Re: Corcoran PUD; No. 07-13; Testimony
On Behalf of Square 643 Associates

RE: Corcoran School of Arts, Southwest, Washington, D.C.
First Street, SW, Loading Dock Feasibility and Traffic Impact Study Update

RE: Site Access Evaluation for Randall School (Corcoran School of Arts)
Planned Unit Development Application, Southwest, Washington, DC.

EXHIBIT 2

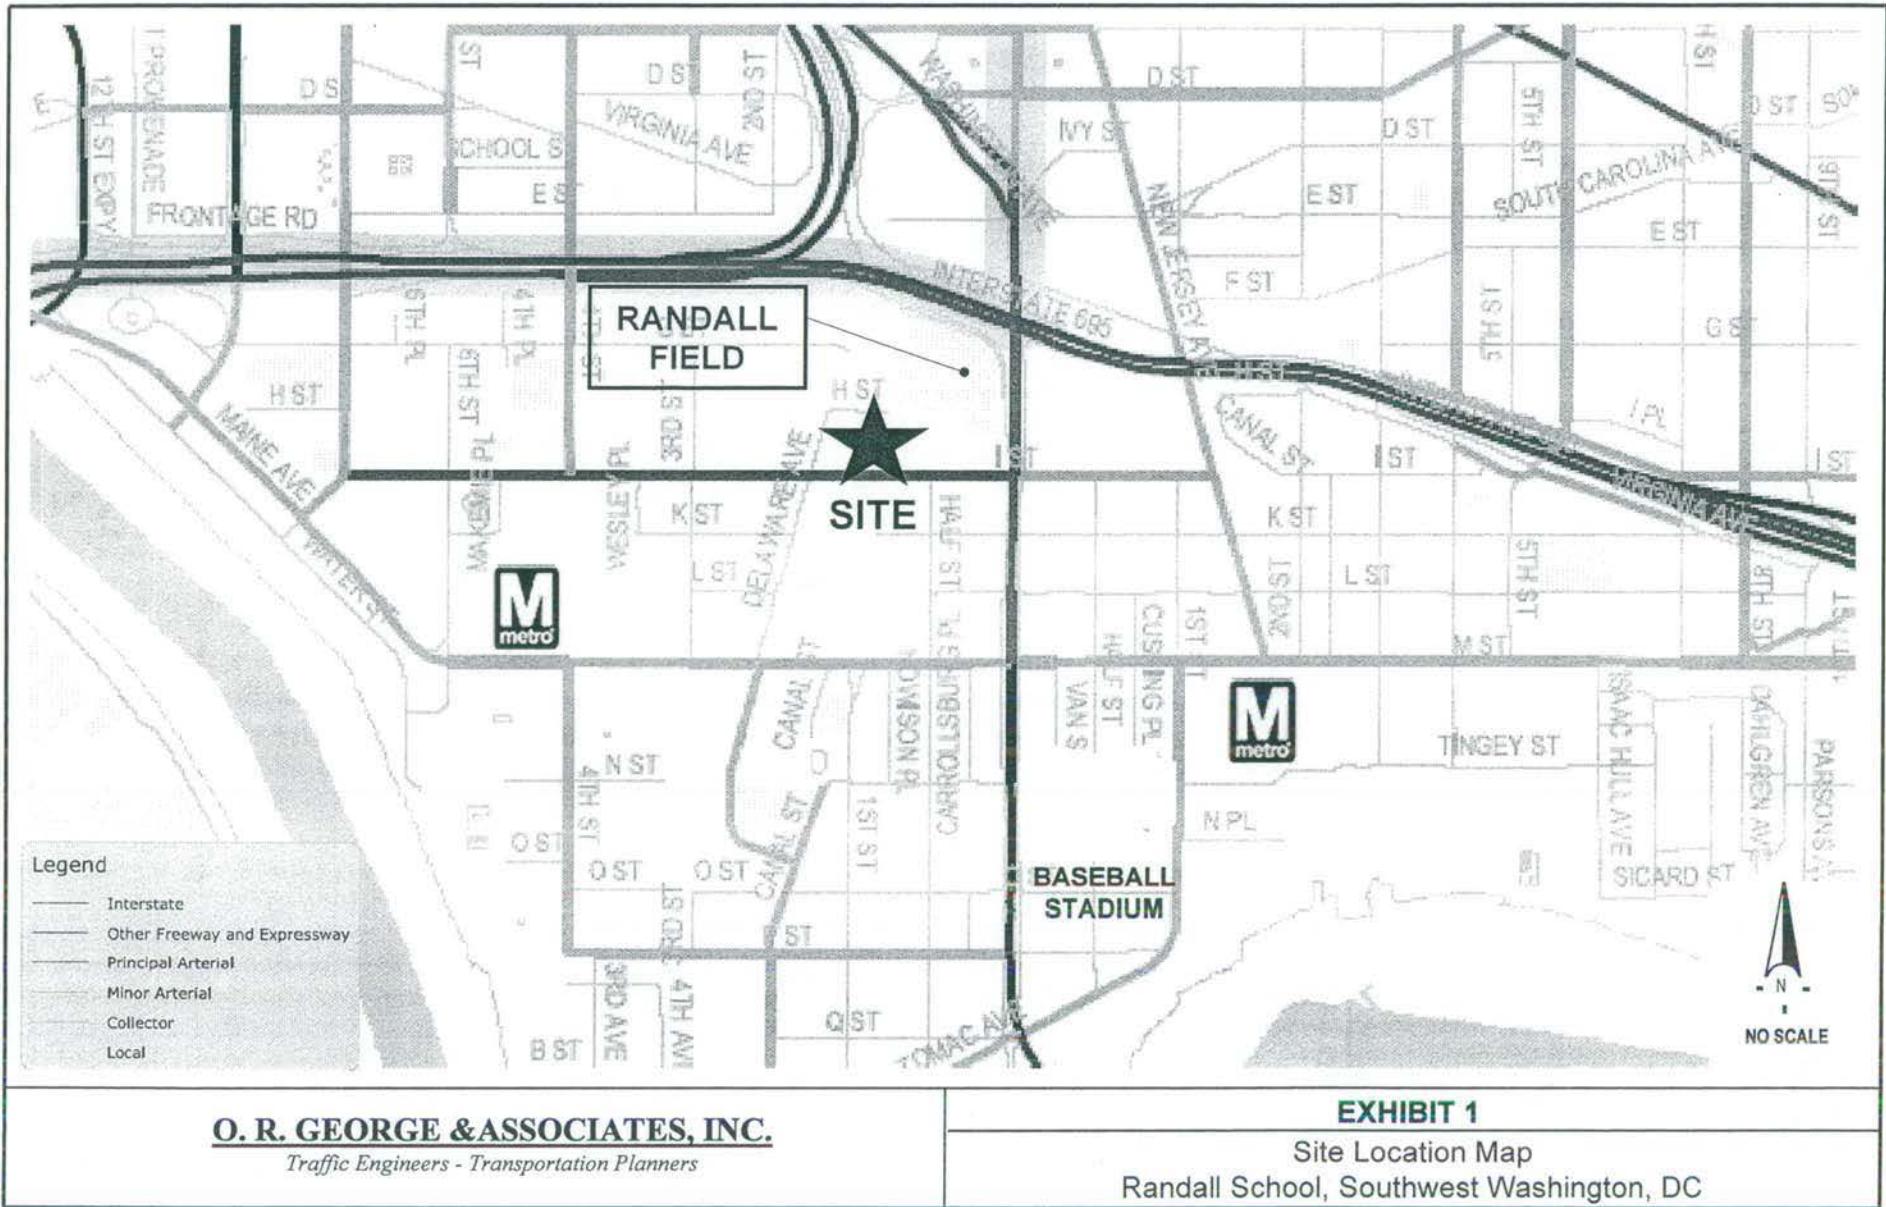
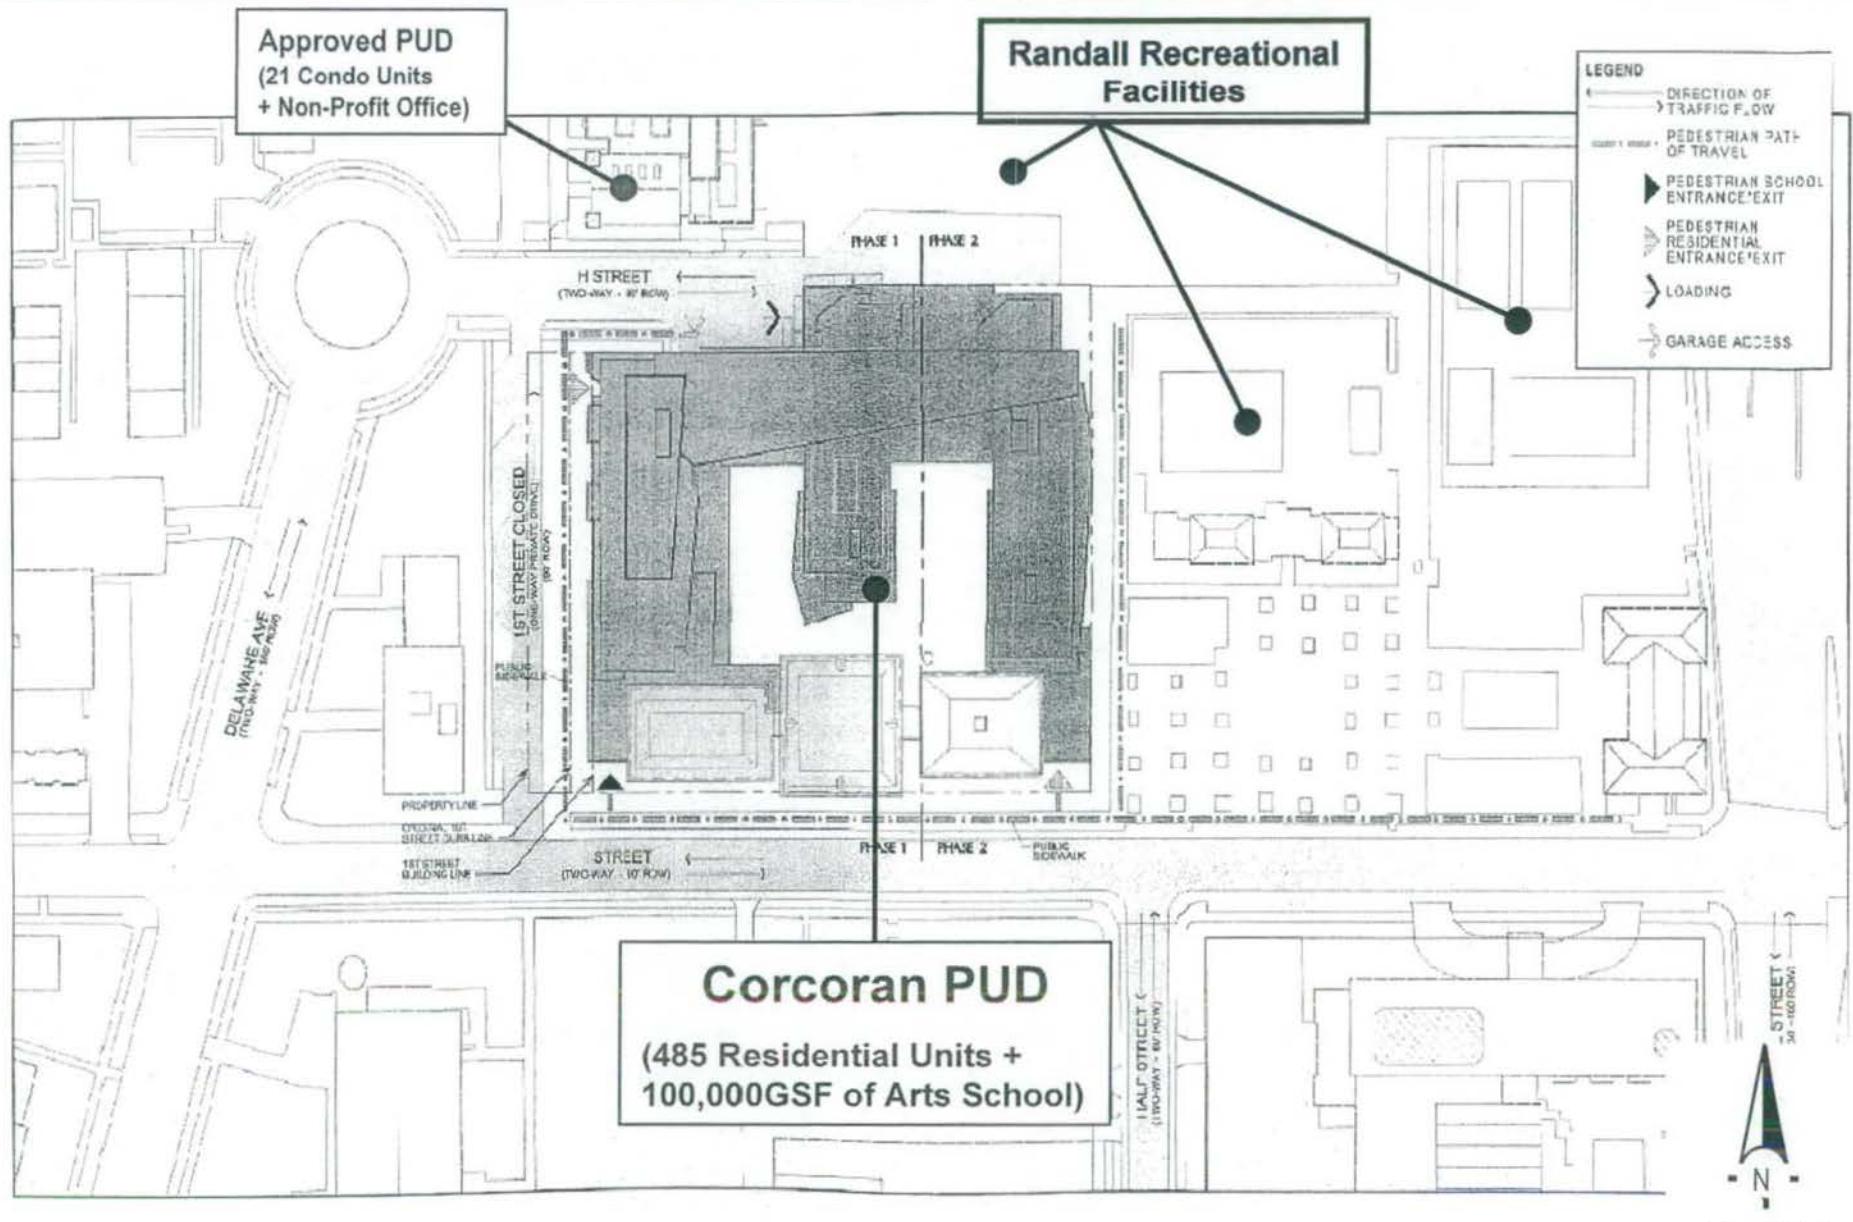
Vehicle trip generation and truck movements will be discussed later under the section dealing with the evaluation of the traffic impact study. However, the site plan clearly shows that all truck and other vehicular movements would be via the "stubbed" section of H Street, through the traffic circle. It is noteworthy that this circle, by its design and associated landscape treatment, can be considered a very local residential community amenity.

Clearly the impacts, associated with these traffic movements on the local area, needs to be addressed. It is perhaps reasonable that particular attention should be paid to the adjacent PUD site, taking into consideration the approved parking entrances.

- a) **General Vehicular Traffic:** The overall vehicular traffic accessing the development would be quite significant. No analysis was performed to examine the operational situation for the section of Delaware Avenue and H Street, including the traffic circle.

- b) **Truck Access:** Considering the types of loading facilities and trucks noted earlier in this section, trucks accessing the site could only do so with a very circuitous maneuver, i.e., north on Delaware Avenue and partially around the circle, and a “backing” movement from the circle along H Street into the loading facility. This situation would specifically require that truck tracking movements around the traffic circle, as well as the maneuvering between the loading facilities, should be illustrated to confirm whether this proposed arrangement would be feasible. It would also show any potential encroachment onto sidewalks, as well as impacts on the adjacent driveways and loading facilities of the abutting properties.

- c) **Truck Access Conflicts:** The number of trucks accessing the site on a daily basis, as per item (b) above, has not been provided. However, with both the residential and institutional delivery needs to be considered, this could be quite significant. The truck movements would also conflict with movements into and out of the garage, which serves both components of the site uses.
